Date: November 4, 2019
To: Beth Callahan, Project Manager, Maine Department of Environmental Protection
Karem Gungor, Environmental Engineer, Maine Department of Environmental Protection
From: Elizabeth M. Ransom, P.G. Ransom Consulting, Inc.
Subject: Nordic Aquafarms, Inc., Land-based Aquaculture Facility, Belfast, Maine
L-28319-26-A-N, Review Comments

This memo provides responses to the Technical Review Memorandum from Karem Gungor to Beth Callahan dated October 3, 2019. For clarity, the entire comment from the technical memorandum has been copied below and italicized. Responses are in regular text, and on the attached plans and figures as referenced below.

CE111

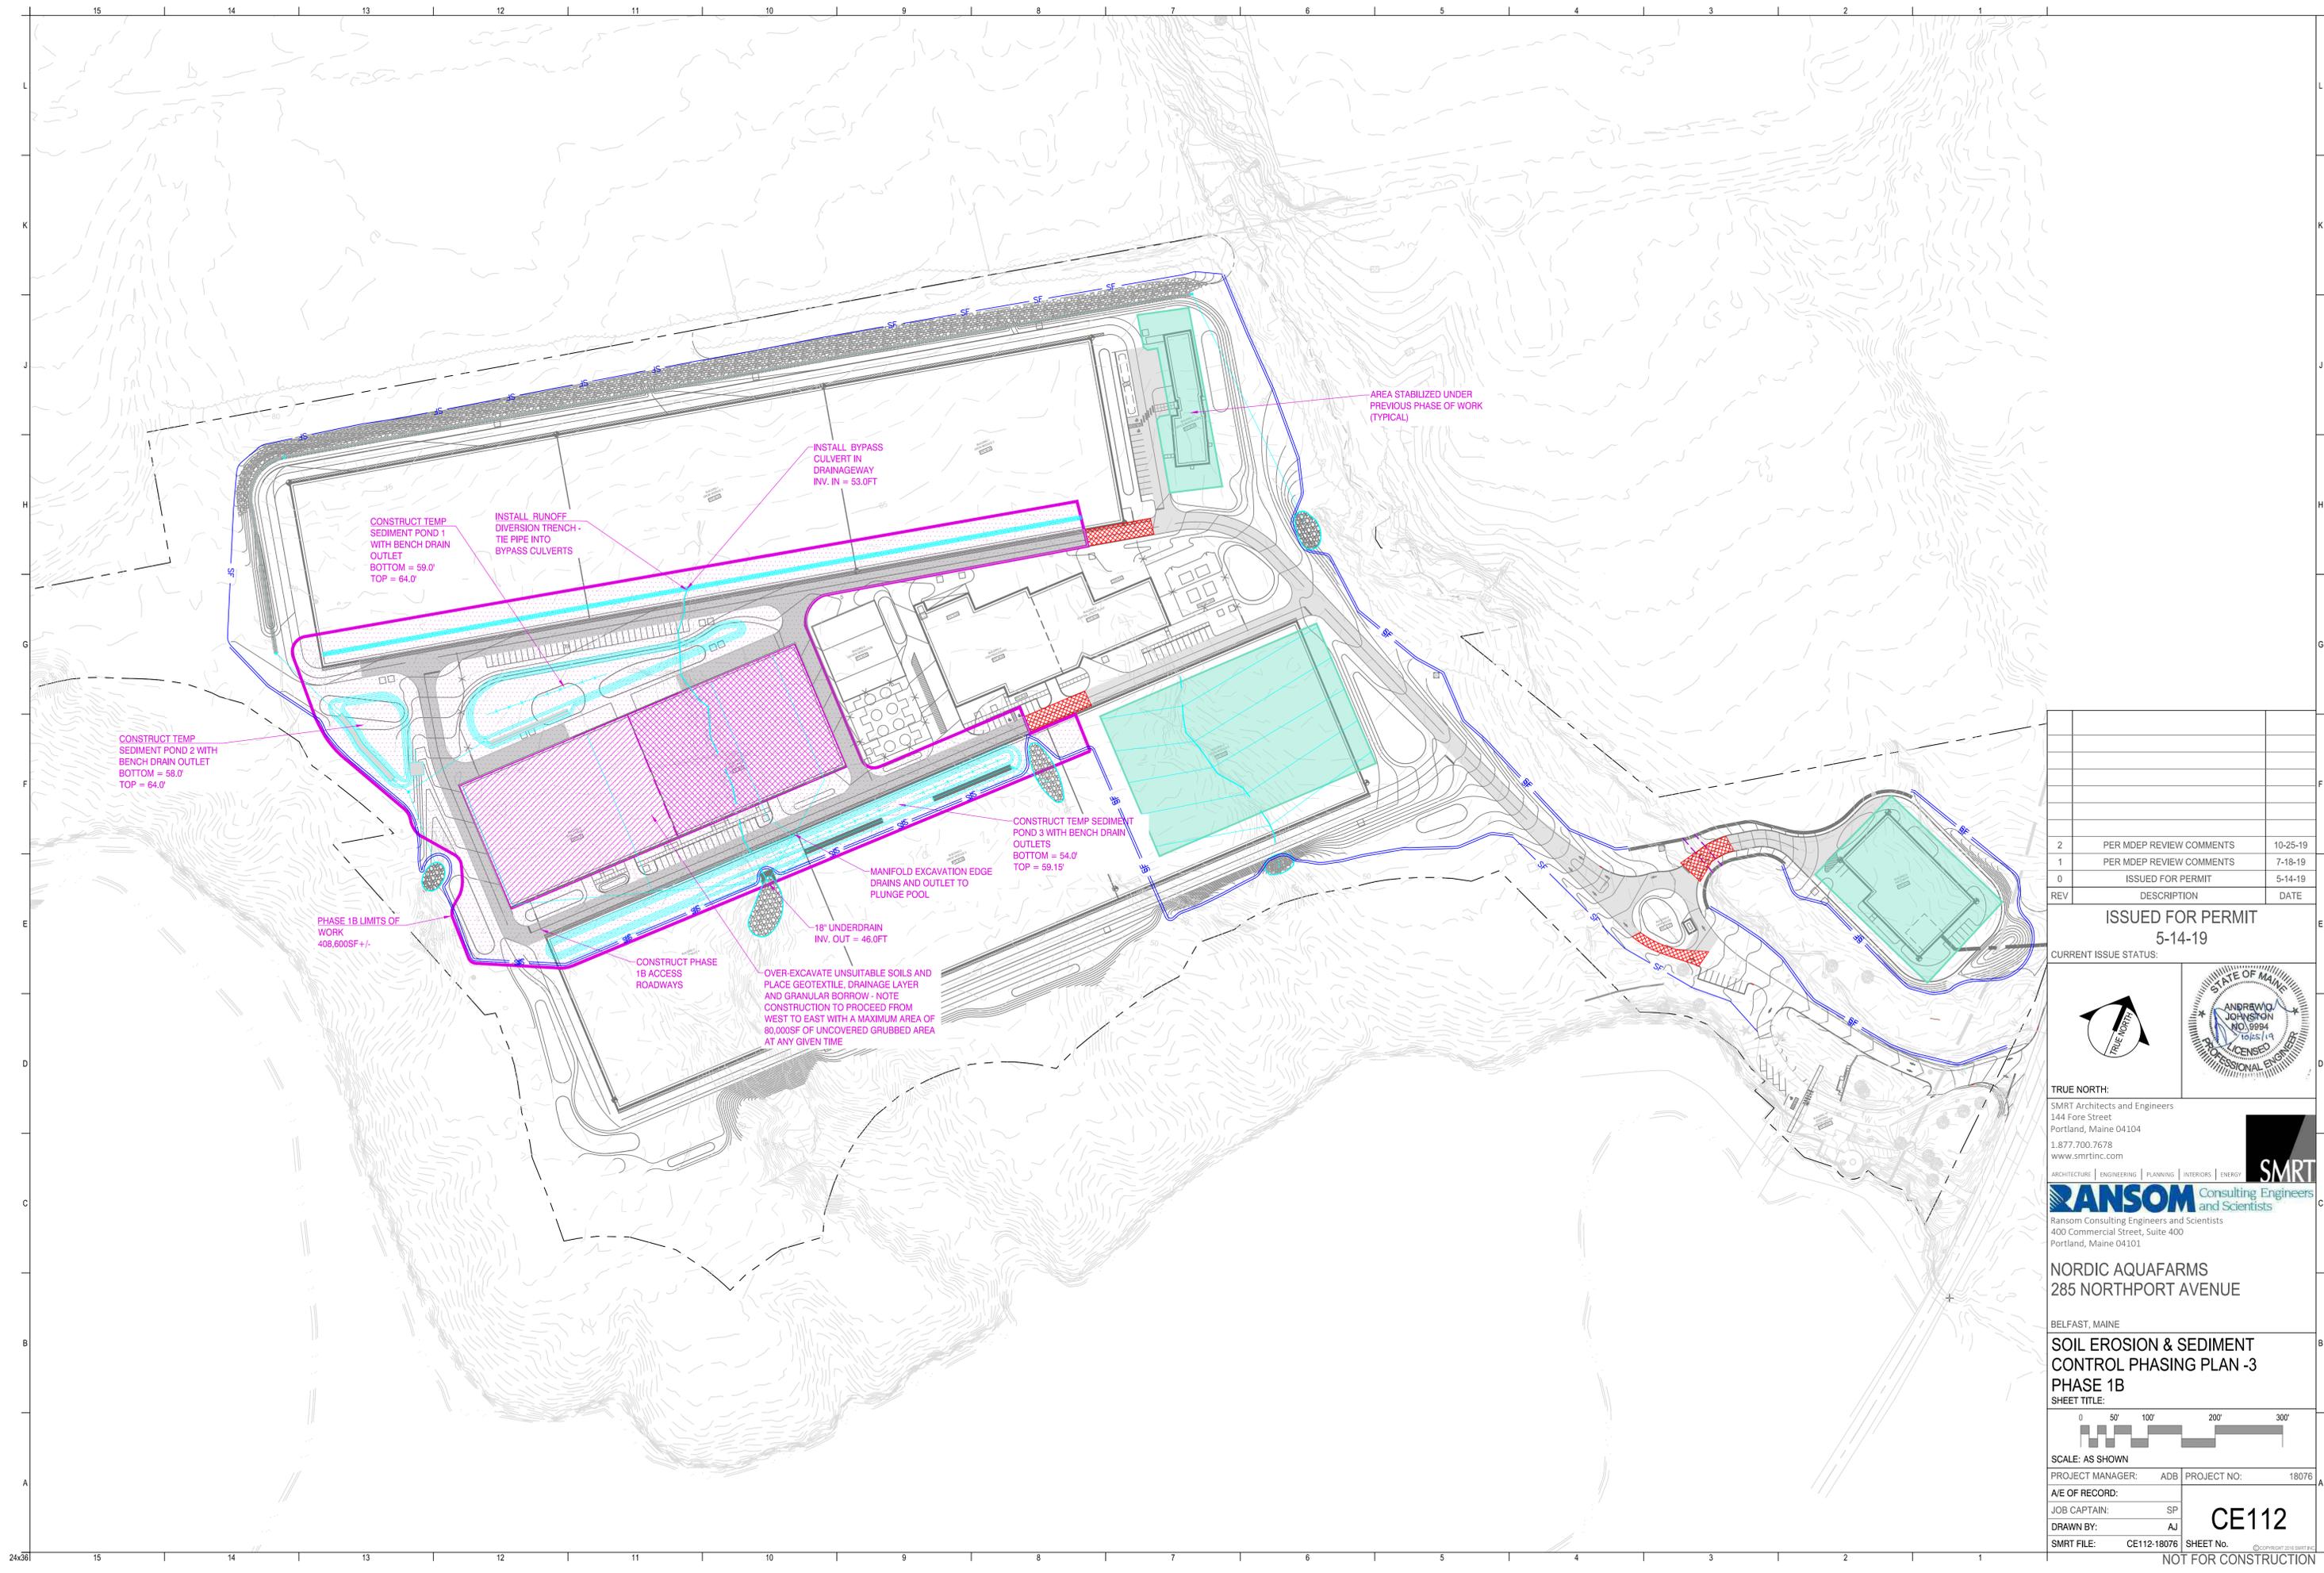
1. First Diversion Trench (Sheet CE111): This trench will not be connected to the edge drain/culvert bypass system as shown in the ESC phasing plans. The trench will intercept the surface runoff from approximately 8.5 acres of upgradient area (see south of Subcatchment 9 flow path in Sheet CW-102) which appears to shed into the streams S3, S5, and S6 under the existing/pre-development conditions. The intercepted flow (surface runoff+ groundwater) will be discharged into an easterly plunge pool based on the underdrain invert elevations provided in Sheet CE111. I recommend the following:

a. Connect the trench underdrain to a bypass culvert or bypass culverts so that the intercepted flow is conveyed southerly and contributes to the baseflow provided for the streams S3, S5, and S6 under the post-development condition,

b. Eliminate the westerly and easterly outfalls of the trench underdrain shown in Sheet CE111. The outfalls may be necessary during the initial phases of the project; but they need to be removed or

deactivated post construction to simulate the pre-development site hydrology to the extent practicable and mitigating the project's hydrologic impact on the jurisdictional streams,

1a. A new extended bypass drain has been added to the plans during Phase 2A of the project. The Phase 1 outlets will be eliminated, and the new drain system will convey flows around the site to discharge at Streams S3, S5, and S6, as requested.

PROJECT MANAGER:	ADB	PROJECT NO.:	18076
A/E OF RECORD:			
JOB CAPTAIN:	SP		
DRAWN BY:	AJ		
SMRT FILE:	CE112-18076	SHEET No.:	CE112

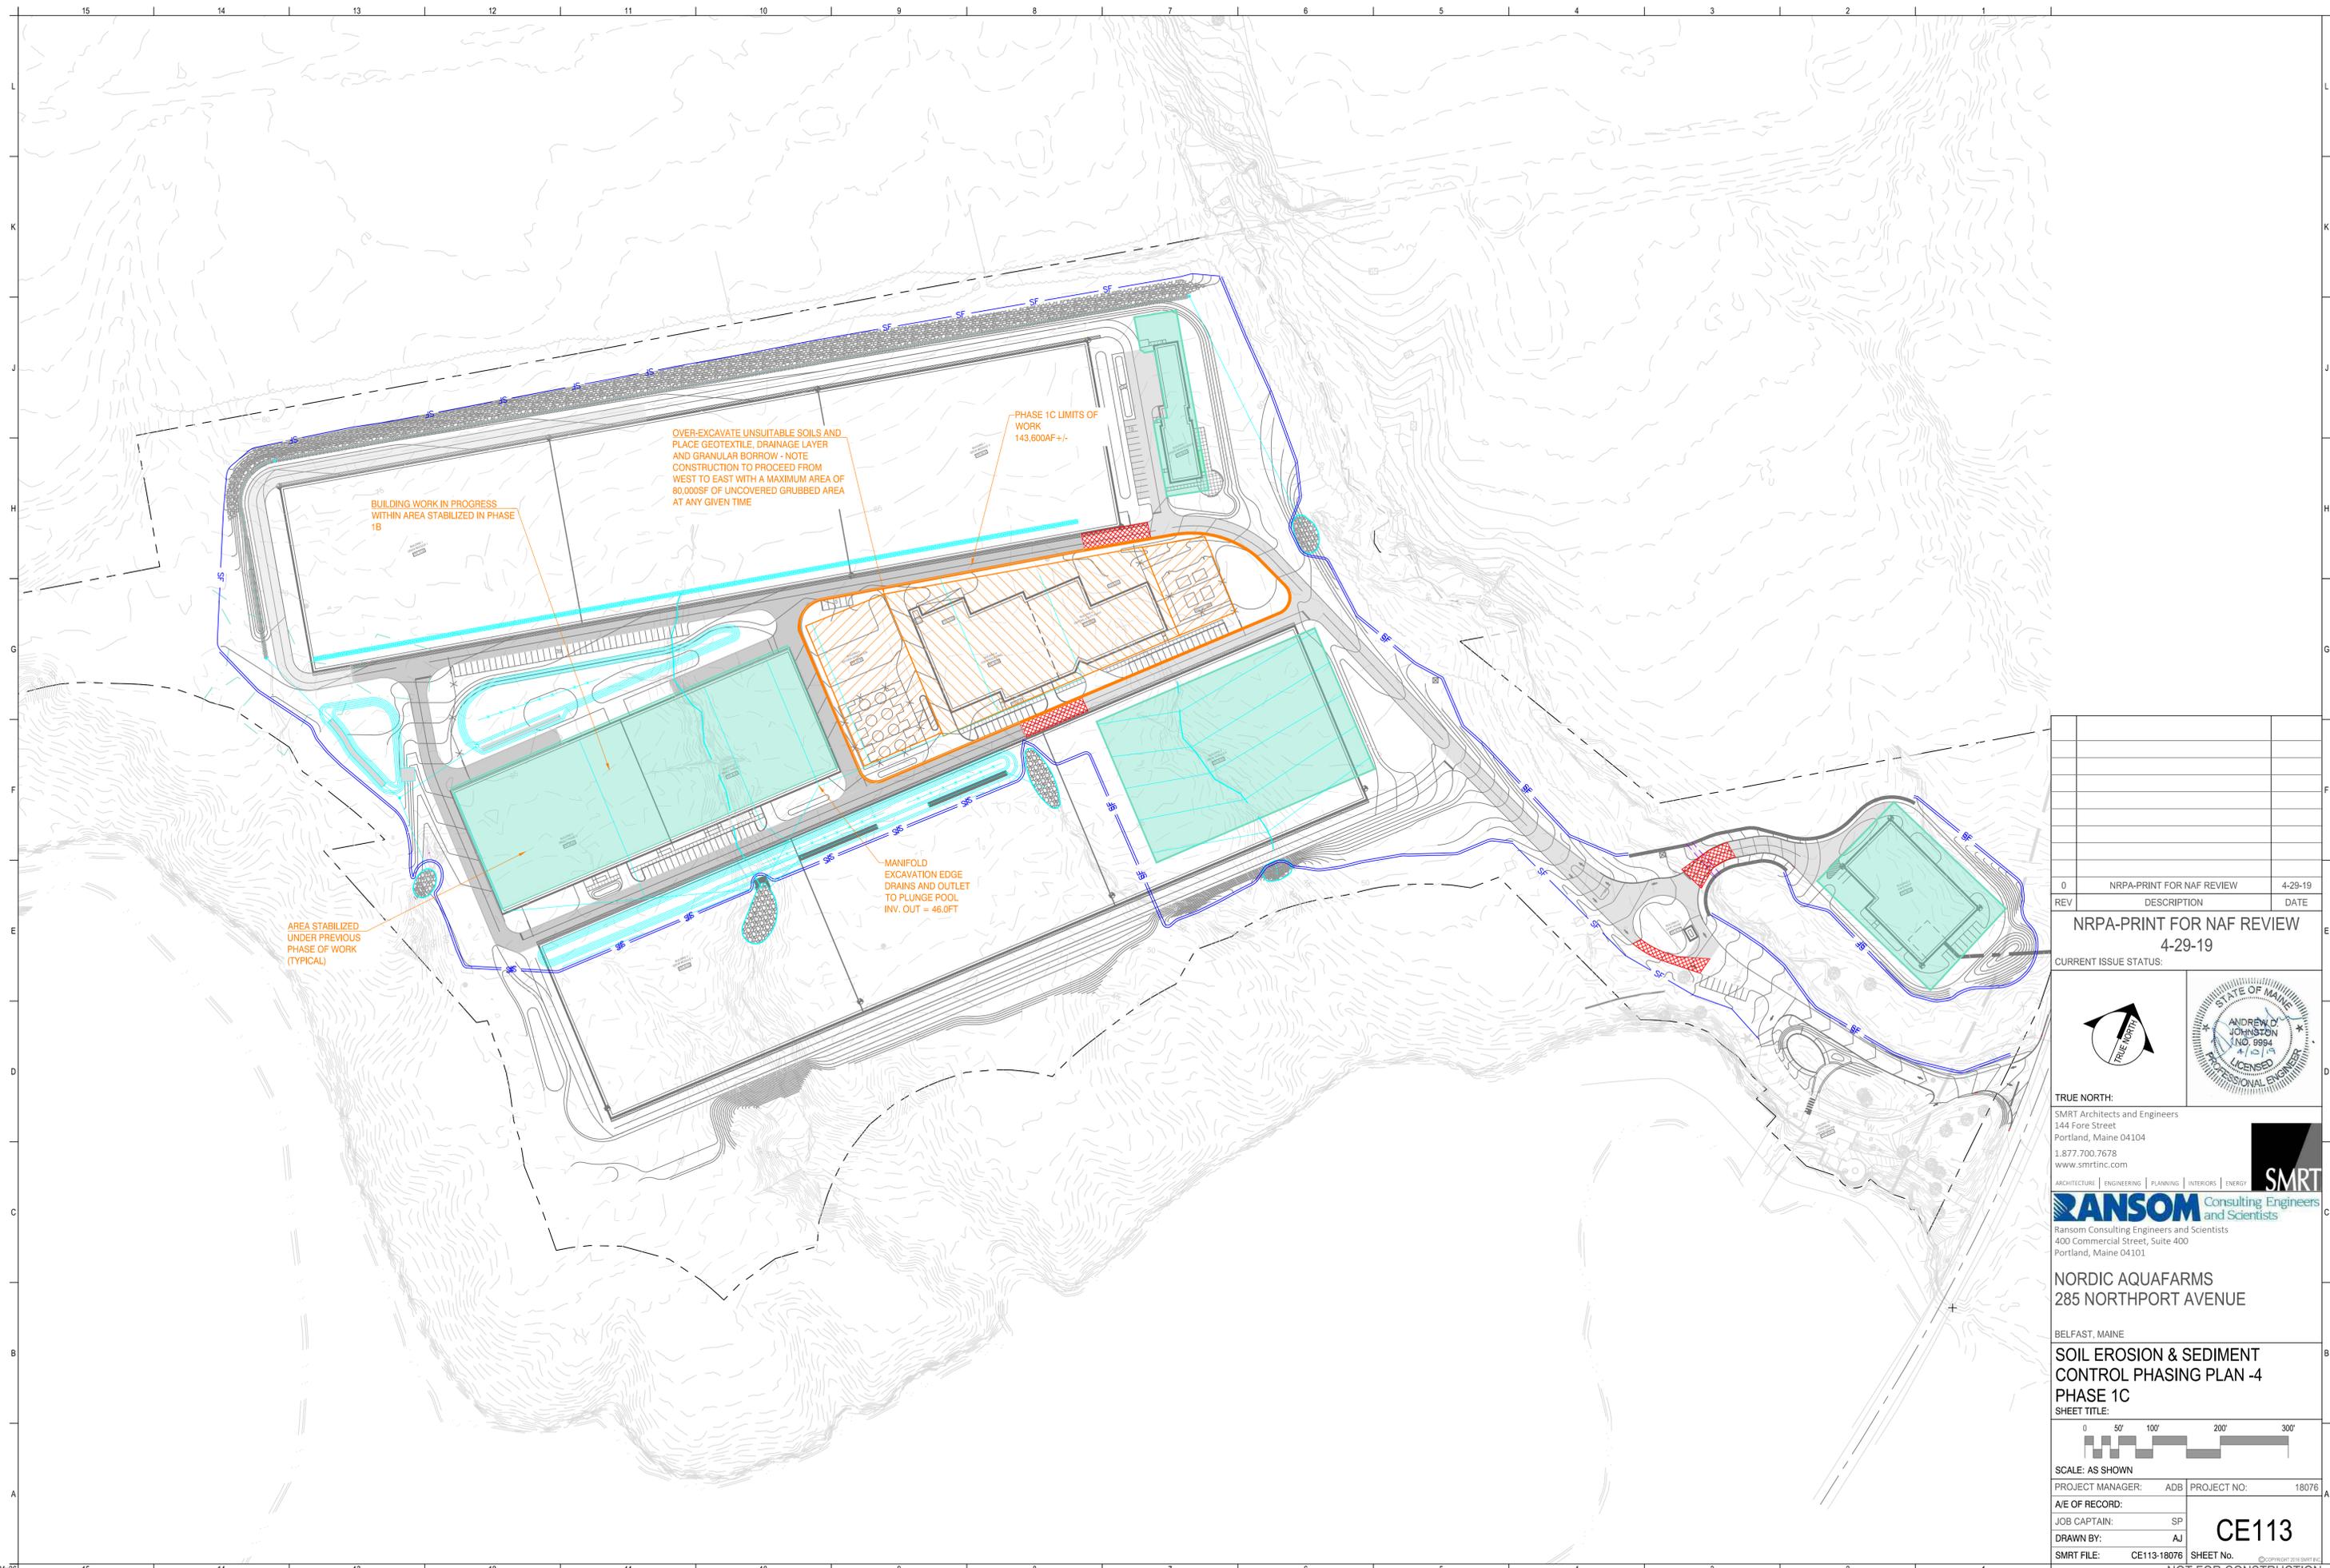
2. *Second Diversion Trench (Sheet CE112): Since this trench will be below the finished floor elevation of Building 1, will it have a minimum crushed stone reservoir depth of 6 ft as shown in Detail ESC-7 in Sheet CE502? A separate detail drawing for this trench is requested.*

During the initial installation, the second diversion trench will be exactly the same as the first, with a crushed stone reservoir to divert groundwater from the surrounding area into the diversion culvert that outlets in a southerly direction to the project limits. The same detail will apply to both trenches (Detail ESC-7 on Sheet CE502). As the excavation and backfill proceeds, the trench will be buried in the backfill section.
